South Texas Project
Units 3 and 4
Docket Nos. 52-012 and 52-013
Response to Request for Additional Information

Reference: Letter: Rocky D. Foster to Scott Head "Request for Additional Information Letter No. 417 Related to SRP Section 01.05 for the Nuclear Innovation North America LLC Combined License Application(ML121230021) dated May 2, 2012.

RAI 01.05-1**QUESTION:**

Figure 1. Comparison of the horizontal STP site-specific SSE, the STP 3 & 4 COLA GMRS (from FSAR Table 2.5S.2-21), and the 2012 Houston CEUS SSC GMRS.

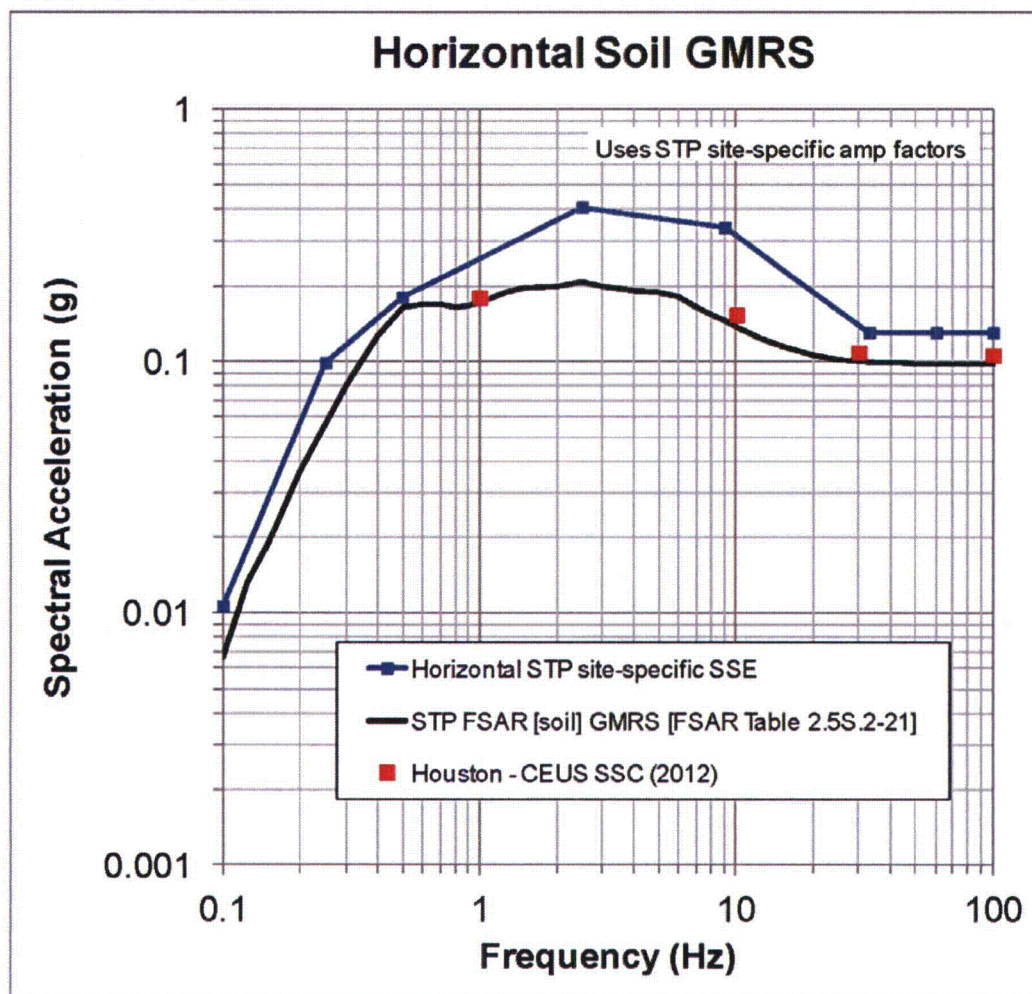
This request for additional information (RAI) specifically addresses Recommendation 2.1, of the Fukushima Near-Term Task Force recommendations contained in SECY-12-0025 as it pertains to the seismic hazard evaluation. This recommendation specifies the use of NUREG-2115, "Central and Eastern United States Seismic Source Characterization for Nuclear Facilities," (CEUS-SSC) in a site probabilistic seismic hazard analysis (PSHA). Consistent with Recommendation 2.1, as well as the need to consider the latest available information in the (PSHA) for South Texas Project Units 3 and 4 planned reactor site, the NRC staff requests that STP:

- a) Evaluate the potential impacts of the newly released CEUS-SSC model, with potential local and regional refinements as identified in the CEUS-SSC model, on the seismic hazard curves and the site-specific ground motion response spectra (GMRS)/foundation input response spectra (FIRS). For re-calculation of the PSHA, please follow either the cumulative absolute velocity (CAV) filter or minimum magnitude specifications outlined in Attachment 1 to Seismic Enclosure 1 of the March 12, 2012 letter "Request for information pursuant to Title 10 of the Code of Federal Regulations 50.54(f) regarding Recommendations 2.1.2.3, and 9.3, of the near-term task force review of insights from the Fukushima Dai-Ichi accident." (ML12053A340).
- b) Modify the site-specific GMRS and FIRS if you determine changes are necessary given the evaluation performed in part a) above.

Using the procedure recommended in RG 1.208 (NRC 2007) (as defined in STP 3 & 4 COLA Section 2.5S.2.6) to develop GMRS spectra from 10^{-4} and 10^{-5} MAFE hazard curves, a hard rock "GMRS" was developed from the three CEUS SSC Houston rock curves and the additional 30 Hz point scaled from a STP 3 & 4 COLA hard rock "GMRS" 100 Hz-to-30 Hz ratio. Again, these values were then assumed to be closely approximate to (and likely conservative for) a CEUS SSC equivalent rock GMRS at the STP 3 & 4 site.

Next, these four points were scaled by the STP FSAR site-specific amplification factors to get approximate CEUS SSC STP 3 & 4 site GMRS points. These points are shown in Figure 1 along with the STP 3 & 4 COLA GMRS spectrum. The figure shows that the estimated CEUS SSC STP 3 & 4 GMRS points developed in this way are very close to, and not significantly above, the STP 3 & 4 COLA points.

Lastly, also shown in Figure 1 is the STP 3 & 4 site-specific SSE. This design spectrum envelops both of the other spectra.

Therefore, on the basis of this evaluation, it is concluded that implementation of the CEUS SSC model for the STP 3 & 4 site would be expected to result in similar or slightly higher GMRS motions than predicted in the FSAR, but that this difference is not significant because it is within reasonably expected uncertainty in the characterization of seismic hazard. In addition, and as shown in Figure 1, both the existing STP 3 & 4 COLA results and the estimated CEUS SSC results for the STP sites are enveloped by the SSE design spectrum.

- b) Because the STP 3 & 4 COLA results and the estimated CEUS SSC results for the STP site are not significantly different, this investigation found no reason to revise the seismic design basis in the STP 3 & 4 COLA based on an implementation of the CEUS SSC (NUREG-2115) model.
